## **VERIFICATION SUBREPORT**

VE-UER-097-MP11.8.2

«Recovery and Utilization of Associated Gas at Bukit Tua LPG Plant – PT. Arsynergy Resources»

For the period: 01/06/2023 to 30/09/2023

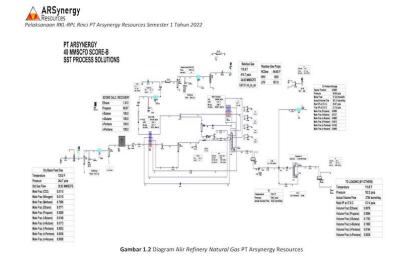
Project boundary is well identified all the GHG sources of the oil and gas separation facility and the processing station, such as the location of the Point F (delivery point) at the Bukit Tua oil and gas collection stations owned PT Petronas Carigali, 3km away from the LPG plant.

The other GHG sources outside the project boundary are also well established as illustrated in Section B.1 of the MR. The pipeline and all the infrastructures were on-site confirmed by the Lead auditor.

The diagram above was also checked against the managing plan of the project activity "RKL-RPL Rinci sem. 1 2022 final.pdf".
